Subject ▶ Change on spindle and screw M6, and discontinuance on ring spring 6

For Models ▶ 8412DH/DWH (Cordless Percussion-Driver Drill)

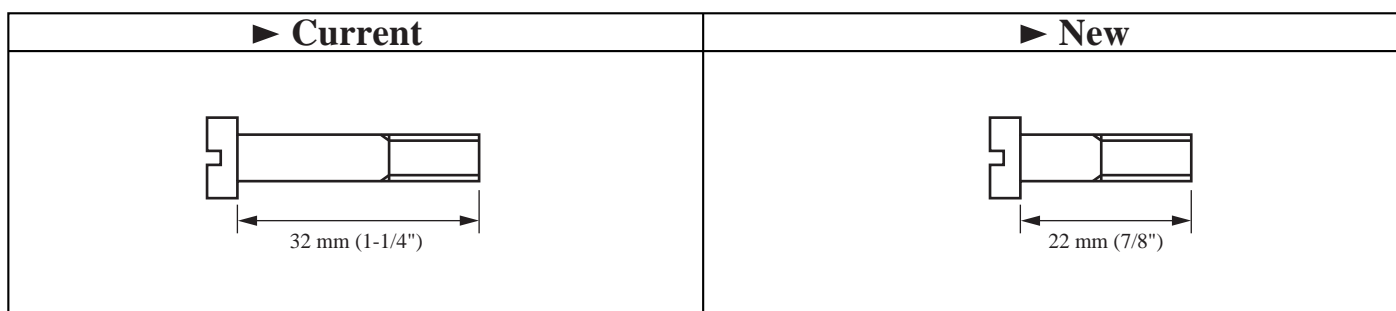
Description ▶ 1. The current type spindle has an internal hexagon. But the new type spindle will have no internal hexagon.

2. The screw M6 will be changed in length.

3. The ring spring 6 will be discontinued.

Item No.	Current part		Q'ty	I/C	New part		Q'ty	Note
15	Spindle 322621-1		1	No	Spindle 322713-6		1	Interchangeable as a set
12	Screw M6x32 251456-2		1	No	Screw M6x22 251425-3		1	
14	Ring spring 6 231959-2		1
